**COMMUNITY DEVELOPMENT  
DEPARTMENT REPORT**

HEARING DATE: 11/19/2024  
TO: Mayor & City Council  
FROM: Linda Ritter, Associate Planner  
208-884-5533  
lritter@meridiancity.org  
APPLICANT: Laren Baily, Conger Group  
SUBJECT: H-2024-0022  
Skyranch AZ, RZ, PP and MDA

# D. Preliminary Plat (date: 5/22/2024)

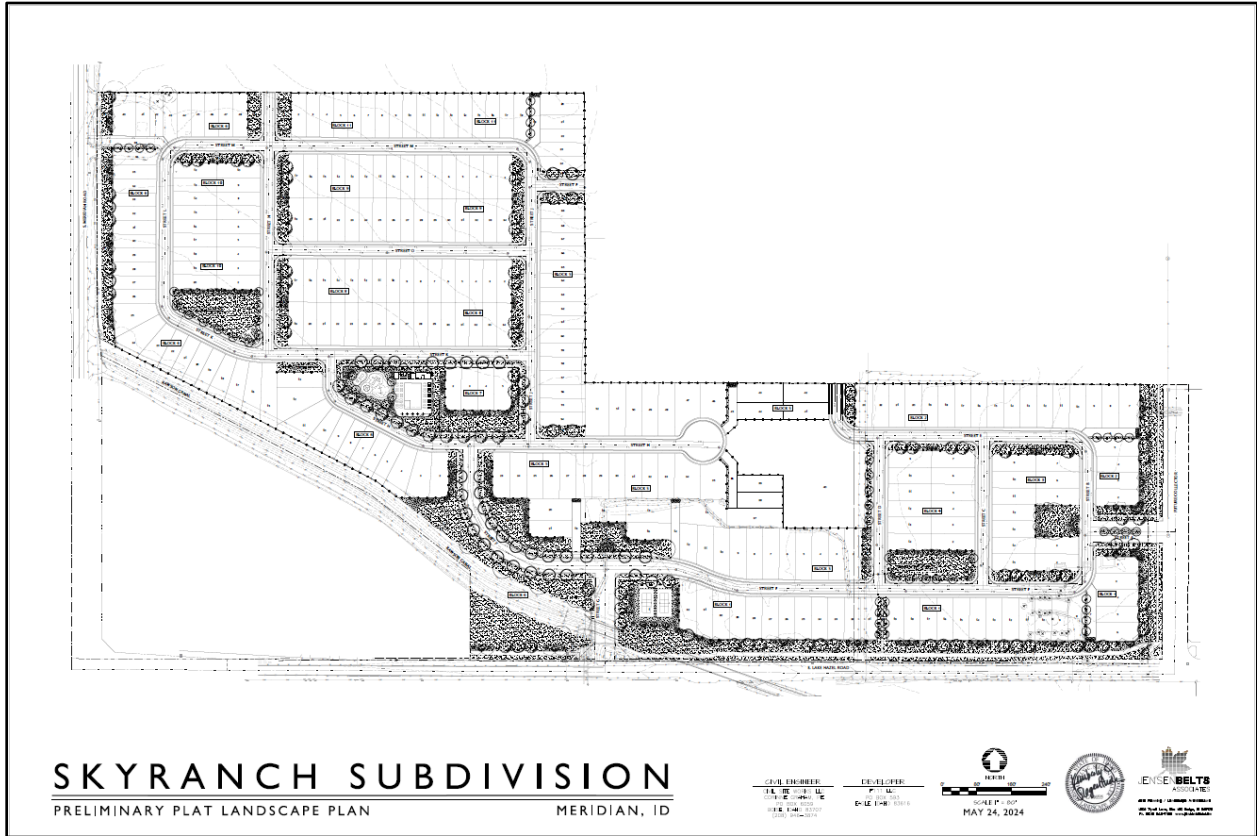
*Staff recommends that the applicant provide a mix of dwelling types within the residential area such as single family attached or townhomes within Block 8 (lots 2-17 and lots 19-34) and Block 9 (lots 2-17 and lots 19-34) of the proposed development as allowed by the Comprehensive Plan within the R-15 zoning district.*

*Per UDC 11-6C-3A.1, through properties are prohibited except where it is shown that unusual topography or other conditions make it impossible to meet this requirement. Through properties shall be limited to one (1) street access on one (1) frontage, designated by a note on the final plat. The applicant needs to revise the plat to remove one of the frontage roads for Lot 40, Block 5.*

*The applicant is proposing a cul-de-sac that exceeds the maximum five hundred (500) feet in length. The applicant needs to request a waiver from counsel for exceeding the maximum length for dead end streets.*

*It appears that some of the block lengths exceed the 750 feet. The applicant did not submit a revised block face length exhibit for review as requested.*

- b. All utility easements reflected on the utility plan shall be included on the final plat.
  - c. Revise the plat map to show larger lots (R-8 zoning districts size) along the north boundary adjacent to the county large estate lots.

- d. All pathways and micro pathways shall be within a separate common lot or easement as required per UDC 11-3A-8.
  - e. Access to Lot 40, Block 5 shall be restricted to either Street H or Street Q. No access shall be allowed to and from the other street until the property redevelops. This shall be added as a note on the plat.

SKYRANCH SUBDIVISION  
LOTS 3-8 BLOCK 1 COMMON DRIVE EXHIBIT

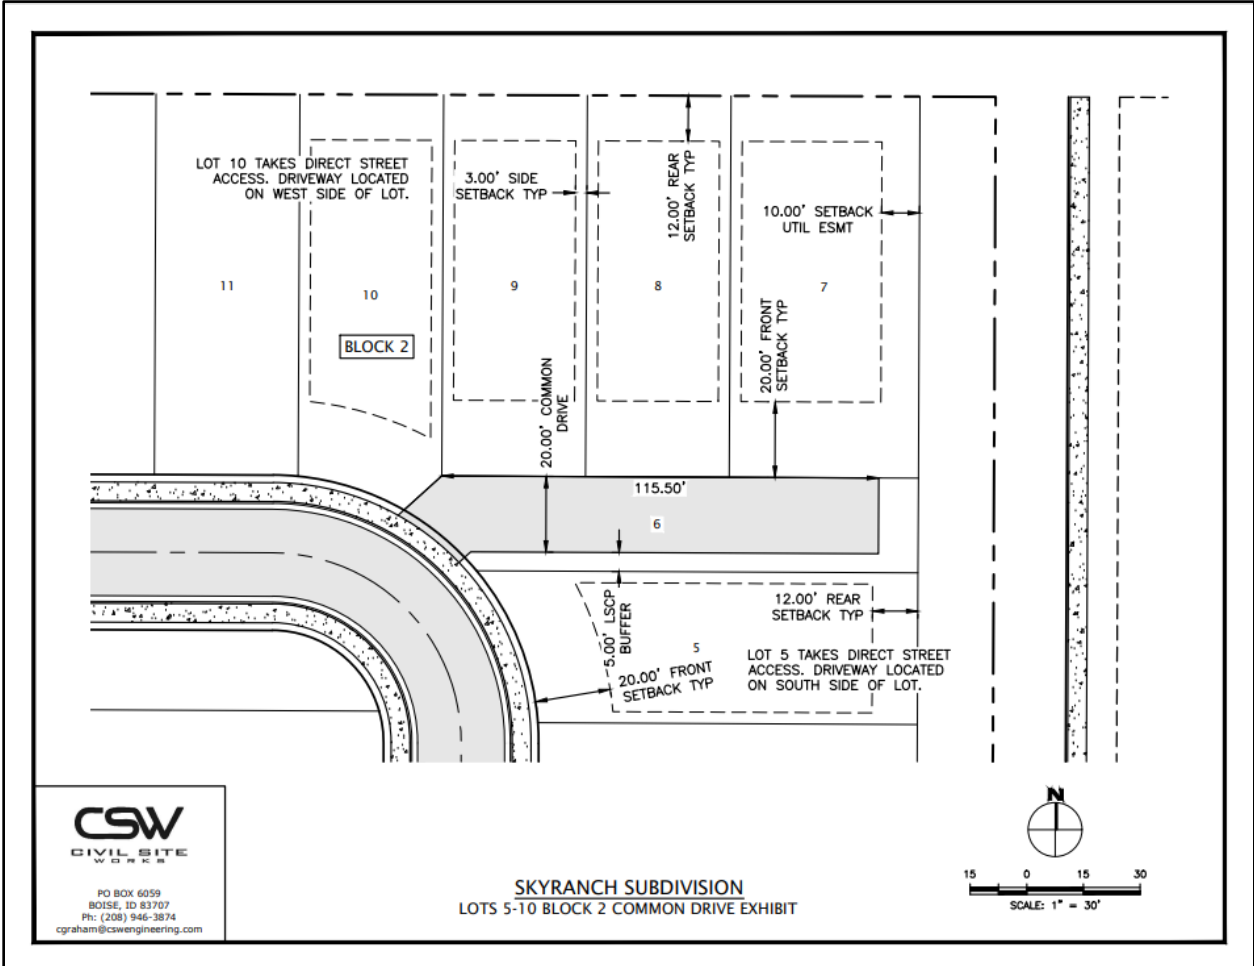
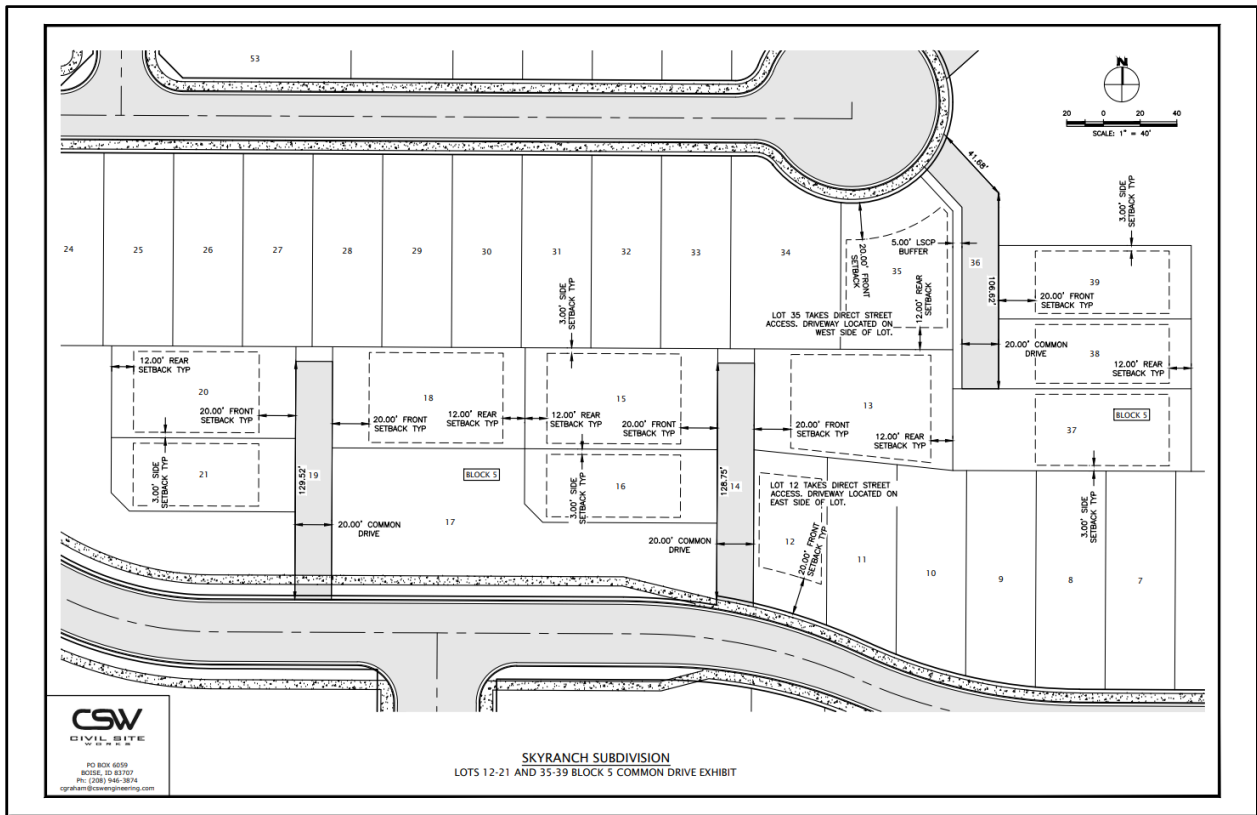
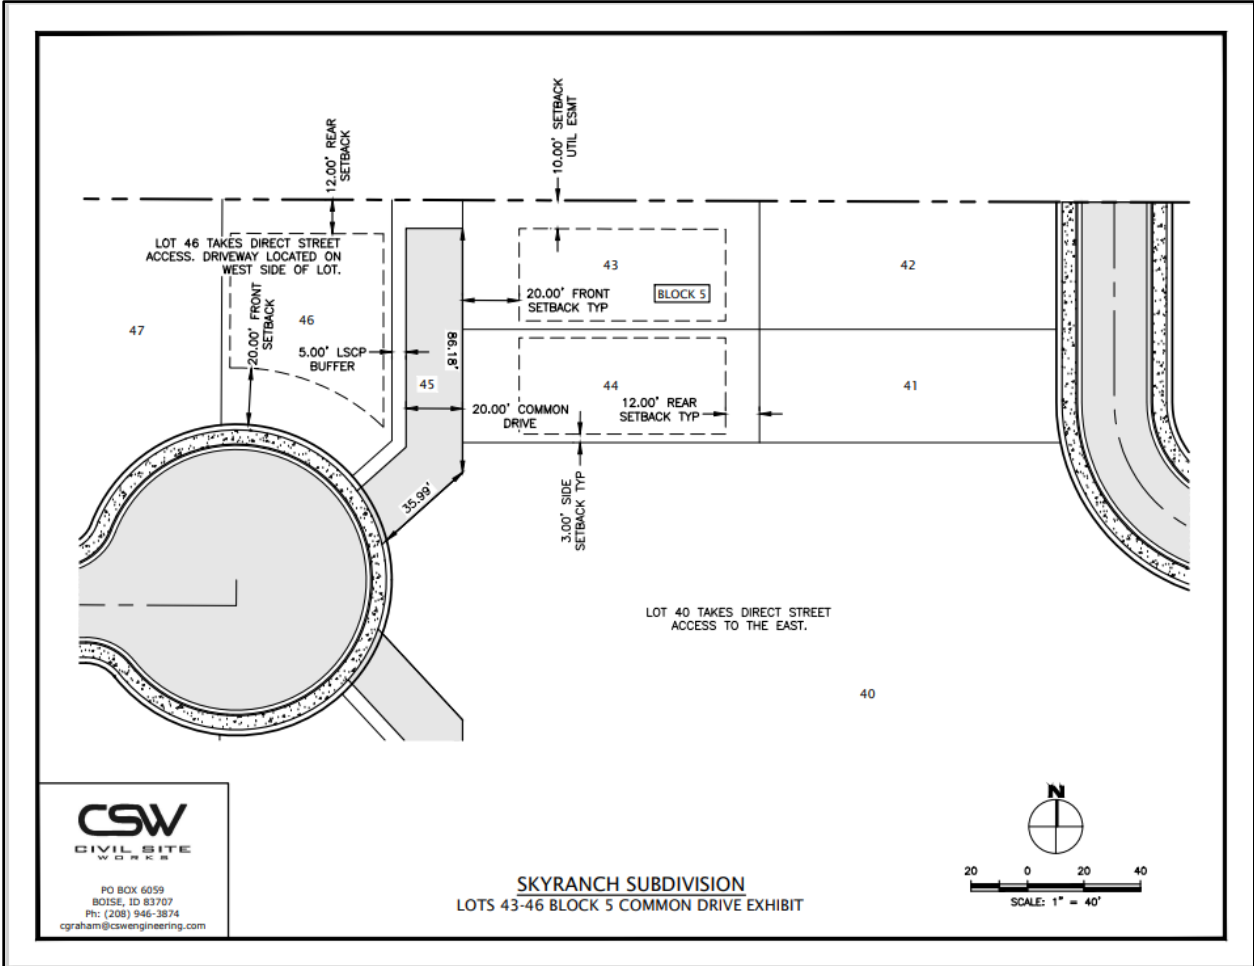
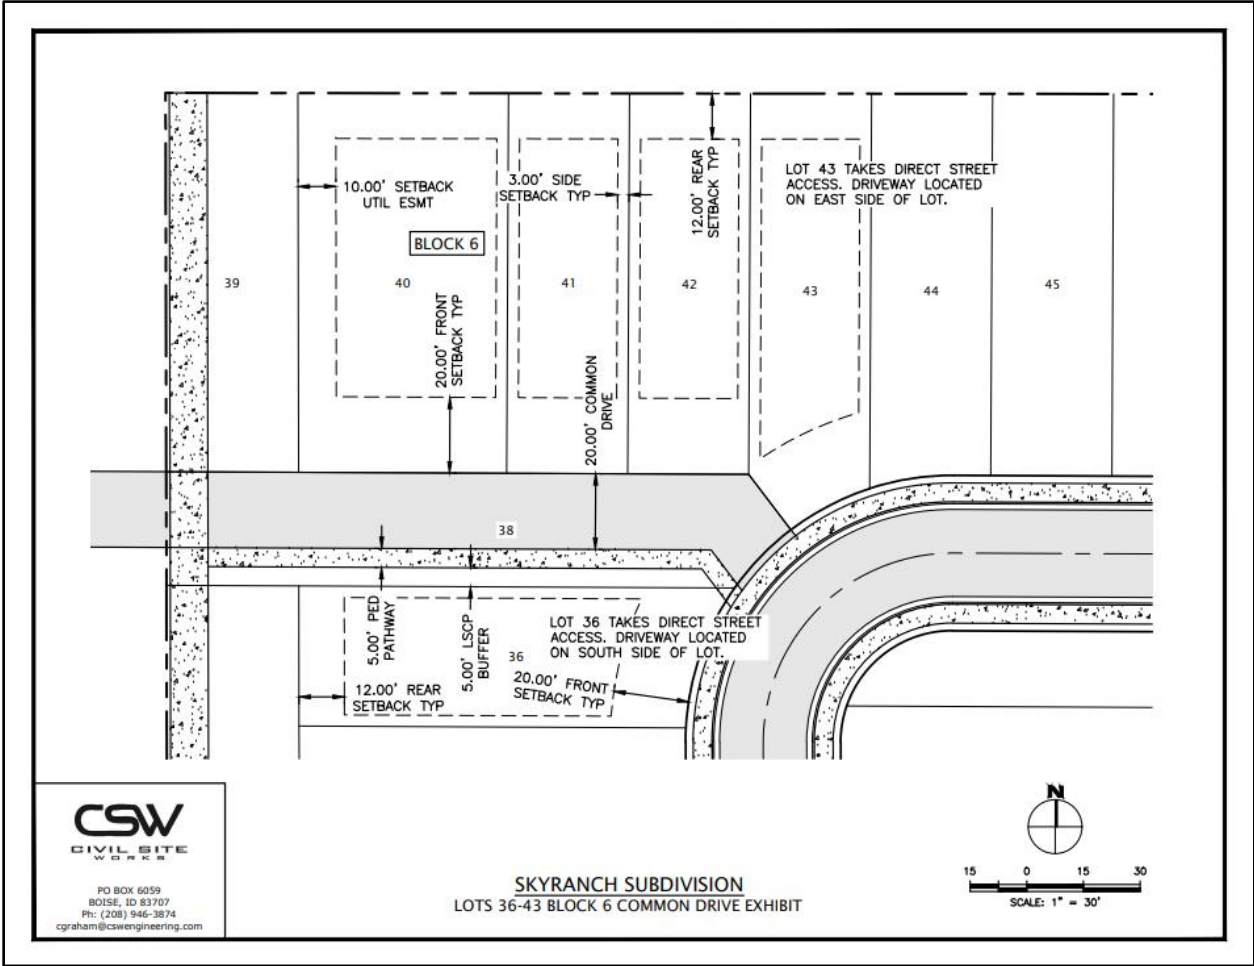
*Eight (8) common driveways are proposed with this subdivision. The applicant has provided common drive exhibits which demonstrate no more than three (3) units are served whereas a maximum of 4 units are allowed. The common driveway meets the minimum width of twenty (20) feet and does not exceed the maximum length of one hundred and fifty (150) feet. Solid fencing adjacent to common driveways is prohibited, unless separated by a minimum five (5) foot wide landscaped buffer.*
